[Docket No. FAA-2004-19969; Directorate Identifier 2004-SW-43-AD; Amendment 39-13923; AD 2004-26-11]

#### Airworthiness Directives; Bell Helicopter Textron Canada Model 222, 222B, 222U, 230, and 430 Helicopters

**ACTION:** Final rule; request for comments.

**Figure 1. Blade inspection area**

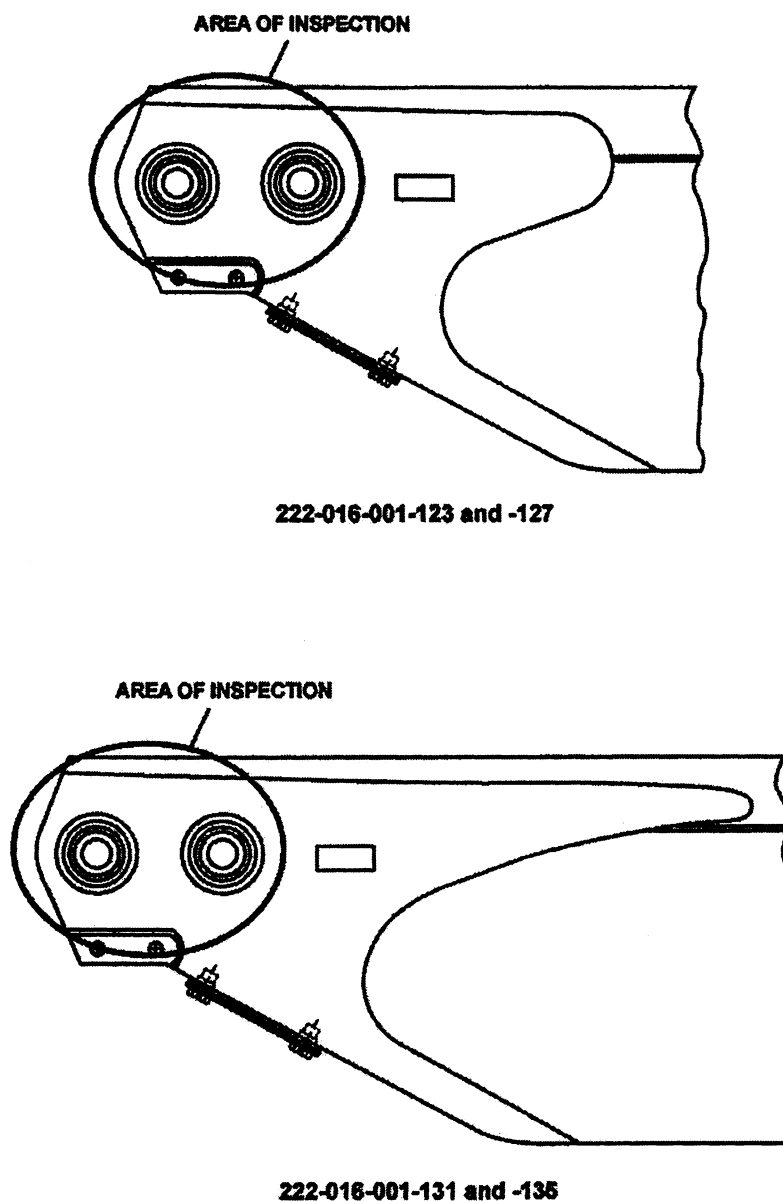
- (a) Within 3 hours time-in-service (TIS) and at intervals not to exceed 3 hours TIS, clean and visually check both sides of each blade for a crack in the paint in the areas shown in Figure 1 of this AD. An owner/operator (pilot), holding at least a private

wiping down both surfaces of each blade in the inspection area depicted in Figure 1 of this AD using aliphatic naphtha (C-305) or detergent (C-318) or equivalents. Using a 10X or higher power magnifying glass, visually inspect both sides of the blade in the areas depicted in Figure 1 of this AD.

(1) If even a crack is found in the paint, before further flight, remove the blade.

(2) Remove the paint to the bare metal in the area of the suspected crack by using Plastic Metal Blasting (PMB) or a nylon web abrasive pad. Abrade the blade surface in a span-wise direction only.

(3) Using a 10X or higher power magnifying glass, inspect the blade for a crack.

(i) If a crack is found, before further flight, replace the blade with an airworthy blade.

(ii) If no crack is found in the blade surface, refinish the blade by applying one coat of MIL-P-23377 or MIL-P-85582 Epoxy Polyamide Primer so that the primer overlaps

the existing coats just beyond the abraded area. Let the area dry for 30 minutes to 1 hour. Then, apply one sealer coat of Polyurethane MILC85285 TYI CL2, color Number 27925 (semi-gloss white) per Fed. Std. 595. Reinstall the blade.
